Project	IEEE 802.16 Broadband Wireless Access Working Group < http://ieee802.org/16 >		
Title	Modifications to support Analog Eigenvector Feedback for MU-MIMO Transmission in the Draft P802.16m Amendment		
Date Submitted	2009-04-27		
Source(s)	Fred Vook, Eugene Visotsky, Bill Hillery, Mark Cudak, Tim Thomas, Bishwarup Mondal, Fan Wang Motorola	E-mail:	fred.vook@motorola.com mark.cudak@motorola.com * http://standards.ieee.org/faqs/affiliationFAQ.html >
Re:	802.16m AWD – Call for Contributions IEEE 802.16m-09/0020 Category: AWD comments / Area: Chapter 15.3.9 (UL-CTRL)		
Abstract	This contribution proposes modifications to the AWD to enable the “eigenvector feedback” methodology mentioned in the UL Control section of the SDD.		
Purpose	Discussion and adoption by TGm		
Notice	<i>This document does not represent the agreed views of the IEEE 802.16 Working Group or any of its subgroups. It represents only the views of the participants listed in the “Source(s)” field above. It is offered as a basis for discussion. It is not binding on the contributor(s), who reserve(s) the right to add, amend or withdraw material contained herein.</i>

Analog Eigenvector Feedback for MU-MIMO Transmission

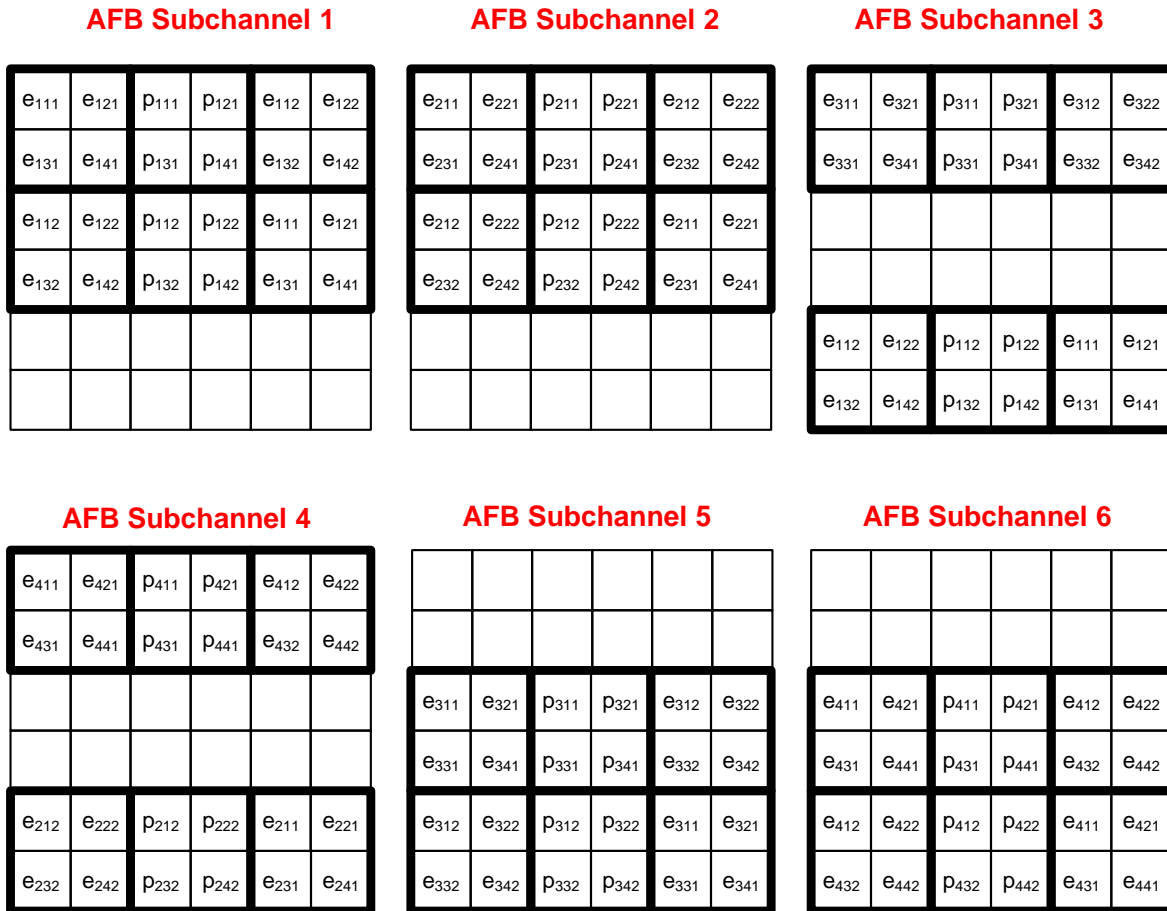
For the MZone, the structure for 2 transmit antennas is shown in Figure UL- 12. The analog feedback (AFB) channel for 2Tx antennas contains 6 analog feedback subchannels for enabling up to 6 AMSs to send analog eigenvector feedback with a CDM factor of 4. In Figure UL- 12, the structure is shown for the first tile of all six AFB subchannels. The structure on the 2nd and 3rd tiles are identical to the structure of the first tile. A blank symbol means the AMS does not transmit on that subcarrier/OFDM symbol. The construction of the information symbols e_{ijk} and pilot symbols P_{ijk} that are transmitted in the AFB subchannels is described in Section 15.3.9.3.4.

Figure UL- 2, Analog Feedback Channel Structure in the Advance Air Interface for 4 Transmit Antenna Base Stations (MZONE): 6 analog feedback subchannels for multiplexing up to 6 AMSs with a CDM factor of 4. Only Tiles 1 and 2 are shown. Tile 3 is identical to Tile 1.

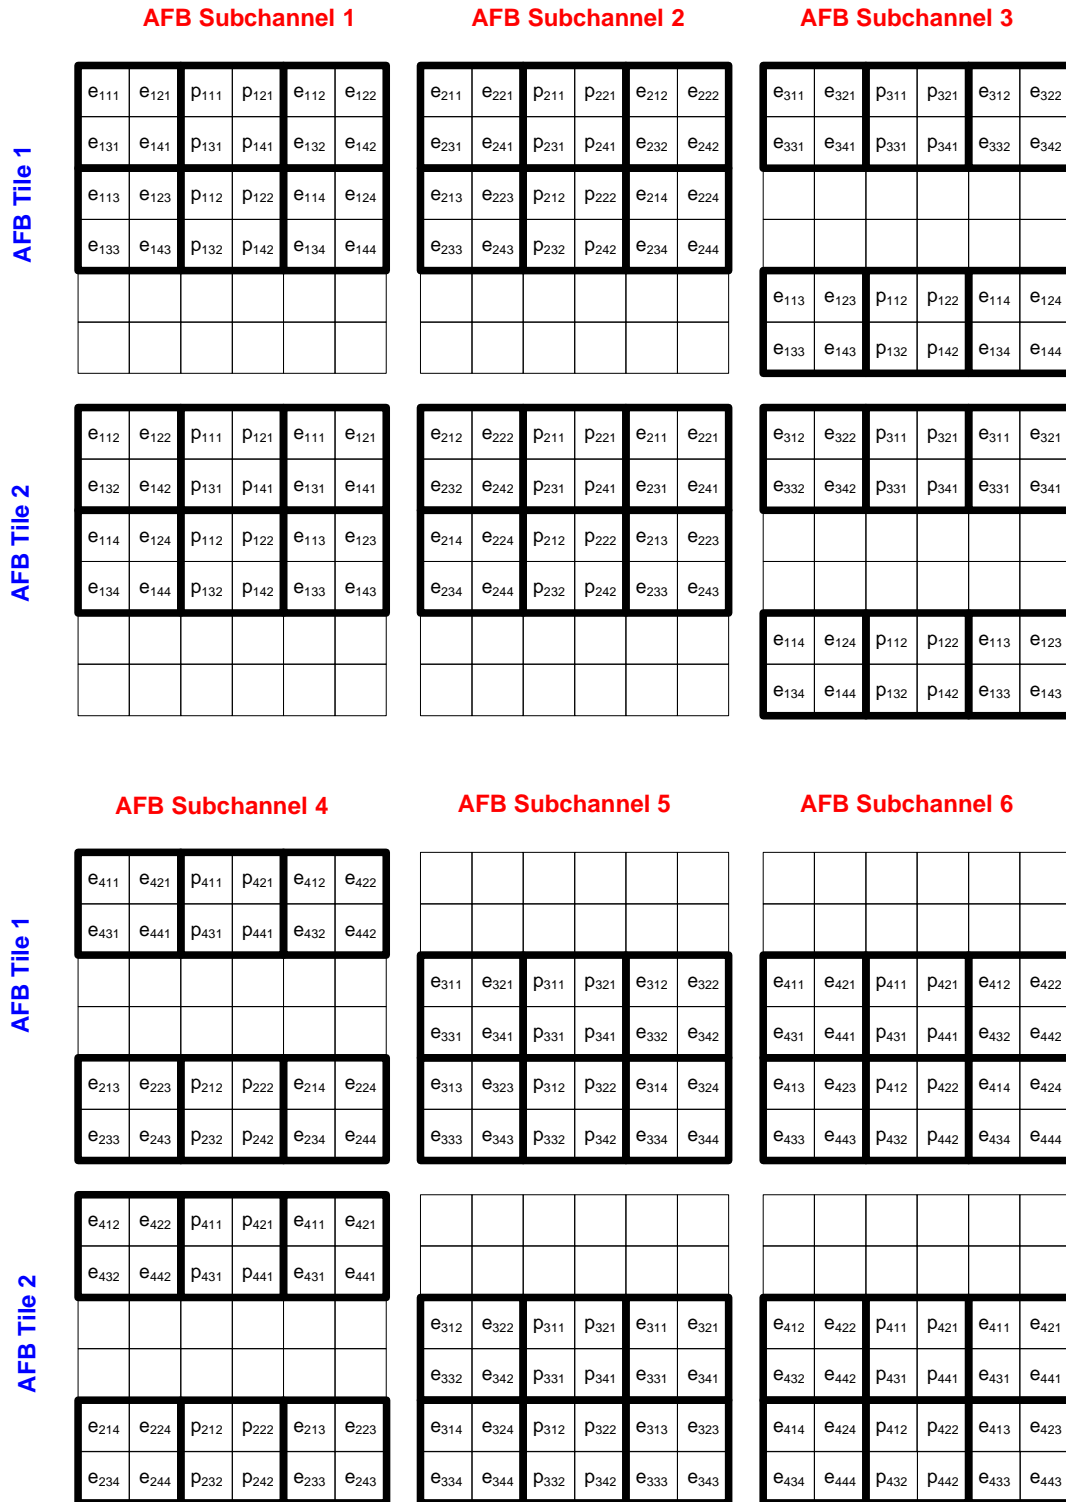
For the MZone, the structure for 4 transmit antennas is shown in Figure UL- 13. The analog feedback channel for 4Tx antennas contains 6 analog feedback subchannels for enabling up to 6 AMSs to send analog eigenvector feedback with a CDM factor of 4. In Figure UL- 13, the structure is shown for the first and second tiles of all six analog feedback subchannels. The structure of the 3rd tile is identical to the structure of the first tile. A blank symbol means the AMS does not transmit on that subcarrier/OFDM symbol. The construction of the information symbols e_{ijk} and pilot symbols P_{ijk} that are transmitted in the AFB subchannels is described in Section 15.3.9.3.4.

Figure UL- 3, Analog Feedback Channel Structure in the Advance Air Interface for 8 Transmit Antenna Base Stations (MZONE). 4 Analog Feedback subchannels for multiplexing up to 4 AMSs with a CDM factor of 4.

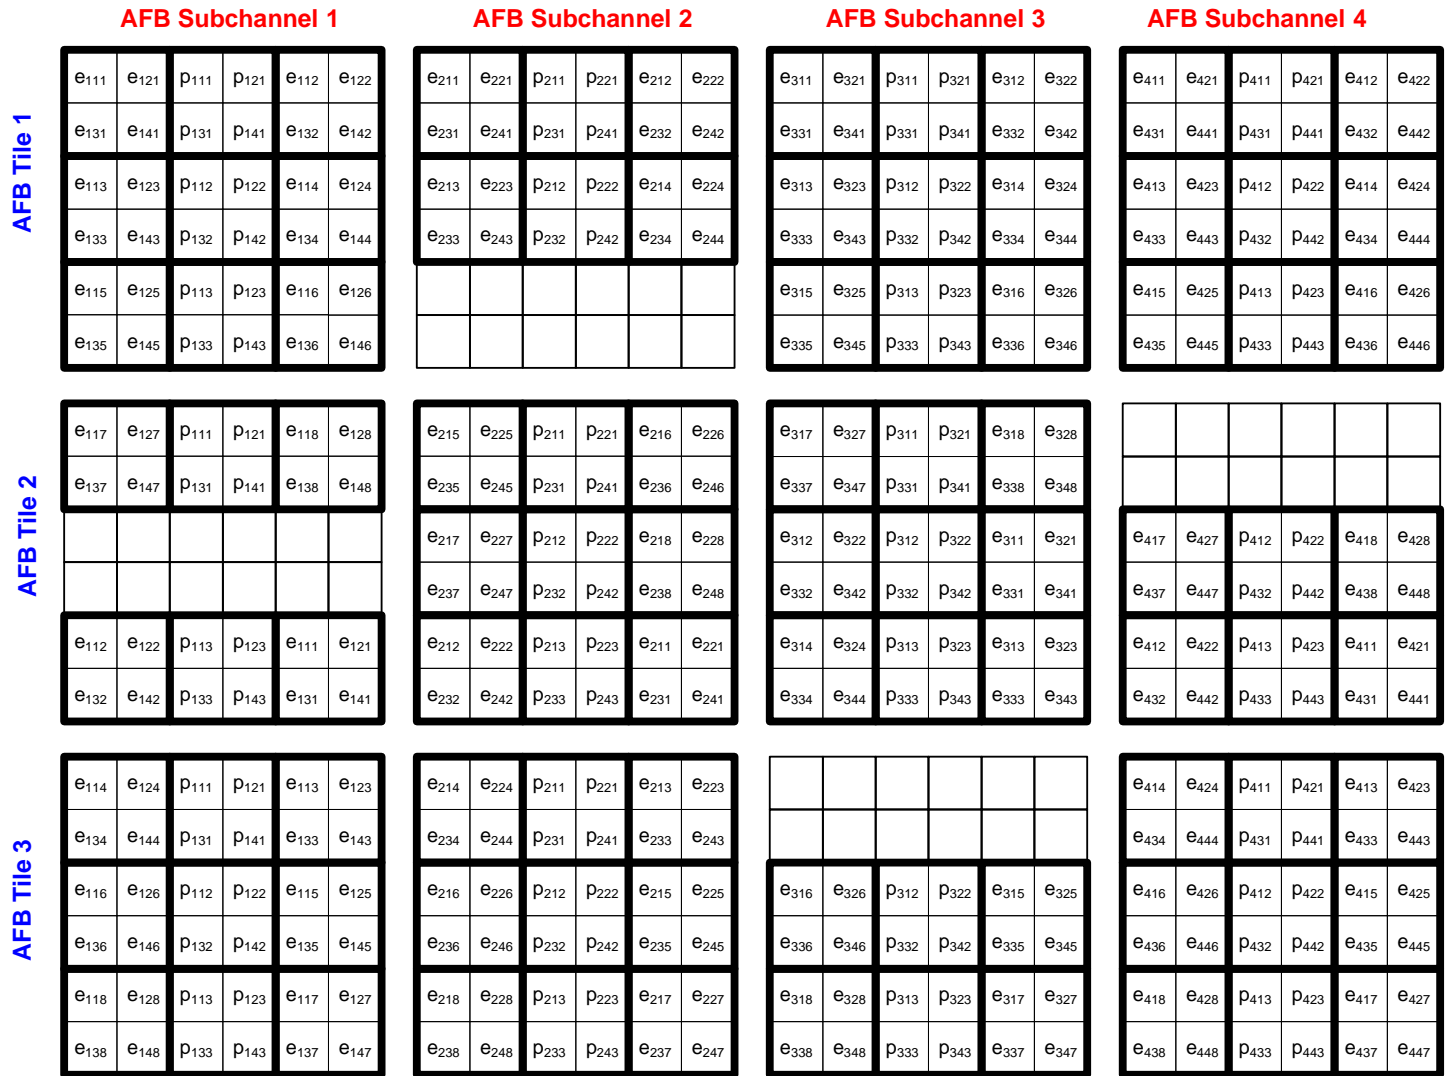
For the MZone, the structure for 8 transmit antennas is shown in Figure UL- 14. The analog feedback channel for 8Tx antennas contains 4 analog feedback subchannels for enabling up to 4 AMSs to send analog eigenvector feedback with a CDM factor of 4. In Figure UL- 14, the structure is shown for all three tiles of all six analog feedback subchannels. A blank symbol means the AMS does not transmit on that subcarrier/OFDM symbol.

Figure UL- 4, Analog Feedback Channel Structure in the Advance Air Interface for 2 Transmit Antenna Base Stations (LZONE): 4 AMSs multiplexed with a CDM factor of 4. Only Tile 1 is shown for the 4 AMSs. Tiles 2 and 3 are identical to Tile 1.

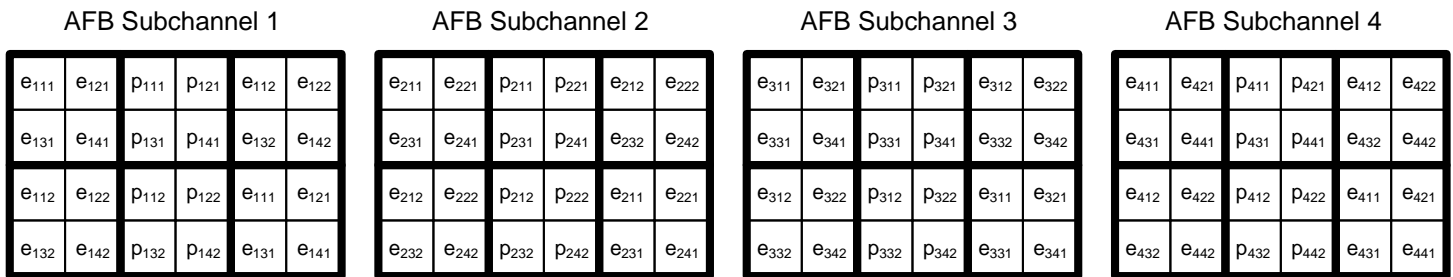
For the LZone, the structure for 2 transmit antennas is shown in Figure UL- 14. The analog feedback channel for 2Tx antennas supports up to 4 AMSs sending analog eigenvector feedback with a CDM factor of 4. In Figure UL- 14, the structure is shown for the first tile of all four users. The structure on the 2nd and 3rd tiles are identical to the structure of the first tile. A blank symbol means the AMS does not transmit on that subcarrier/OFDM symbol. The construction of the information symbols e_{ijk} and pilot symbols p_{ijk} that are transmitted in the AFB subchannels is described in Section 15.3.9.3.4.

Figure UL- 5, Analog Feedback Channel Structure in the Advance Air Interface for 4 Transmit Antenna Base Stations (LZONE): 4 AMSs multiplexed with a CDM factor of 4. Only Tiles 1 and 2 are

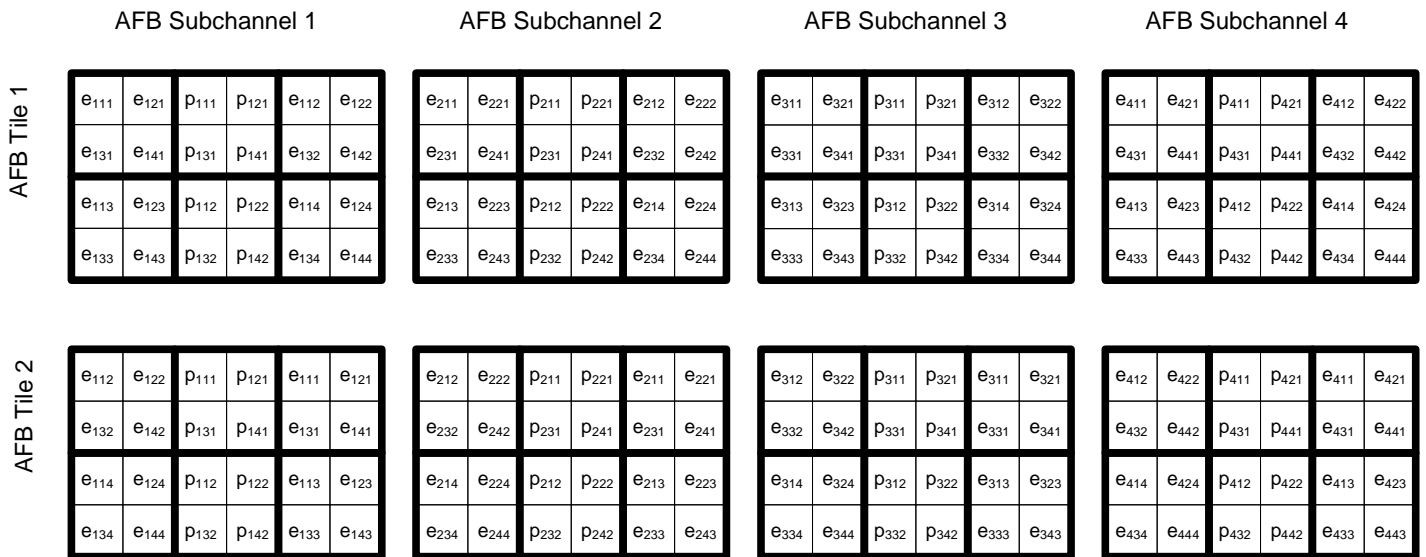
For the LZone, the structure for 4 transmit antennas is shown in Figure UL- 15. The analog feedback channel for 4Tx antennas supports up to 4 AMSs sending analog eigenvector feedback with a CDM factor of 4. In Figure UL- 15, the structure is shown for the first and second tile of all four AMSs. The structure on the 3rd tile

is identical to the structure of the first tile. A blank symbol means the AMS does not transmit on that subcarrier/OFDM symbol. The construction of the information symbols e_{ijk} and pilot symbols p_{ijk} that are transmitted in the AFB subchannels is described in Section 15.3.9.3.4.

Figure UL- 6, Analog Feedback Channel Structure in the Advance Air Interface for 8 Transmit Antenna Base Stations (LZONE): 3 AMSs multiplexed with a CDM factor of 2.

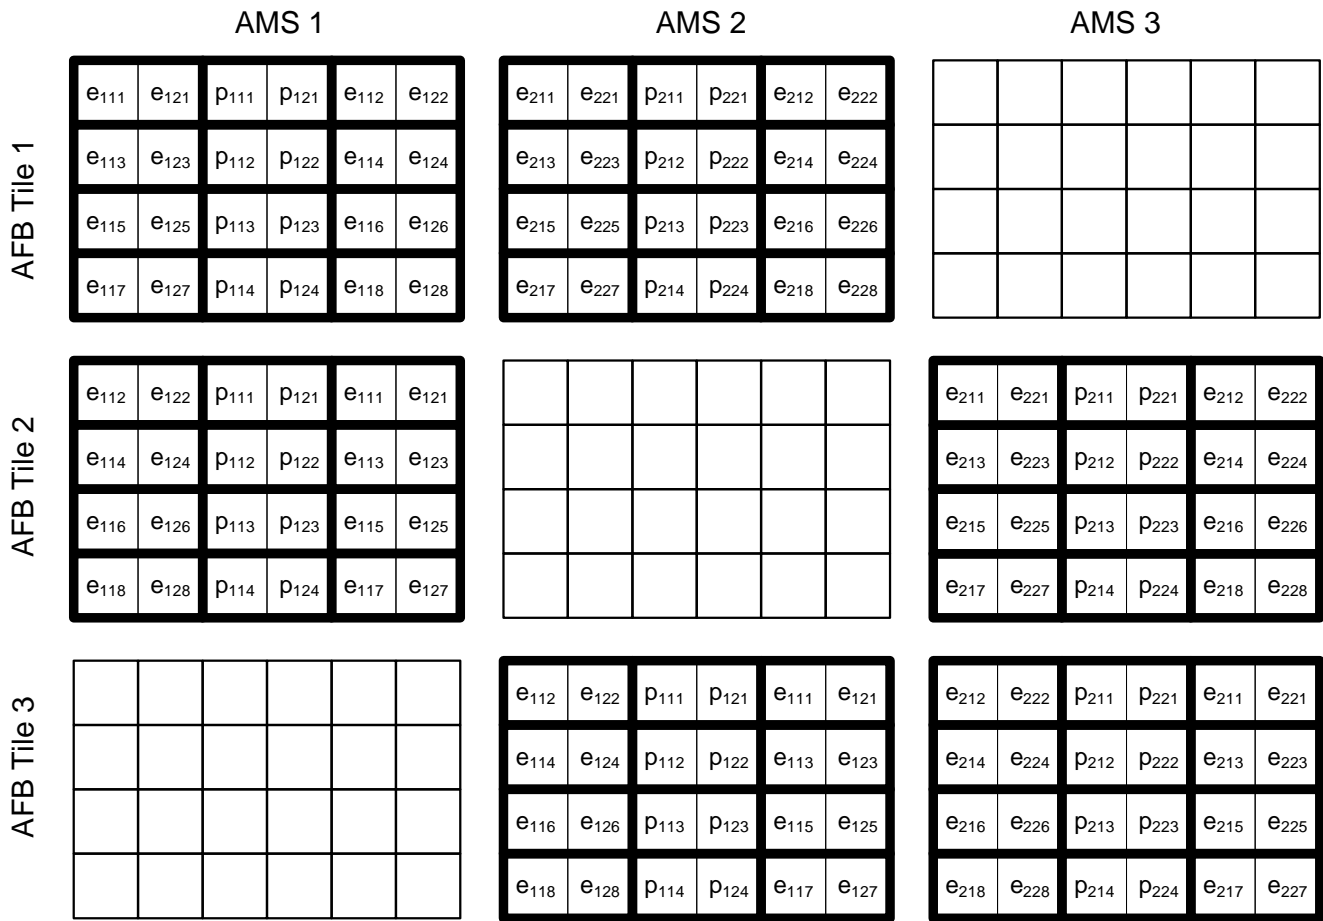
For the LZone, the structure for 8 transmit antennas is shown in Figure UL- 16. The analog feedback channel for 8Tx antennas supports up to 3 AMSs sending analog eigenvector feedback with a CDM factor of 2. A blank symbol means the AMS does not transmit on that subcarrier/OFDM symbol. The construction of the information symbols e_{ijk} and pilot symbols p_{ijk} that are transmitted in the AFB subchannels is described in Section 15.3.9.3.4.
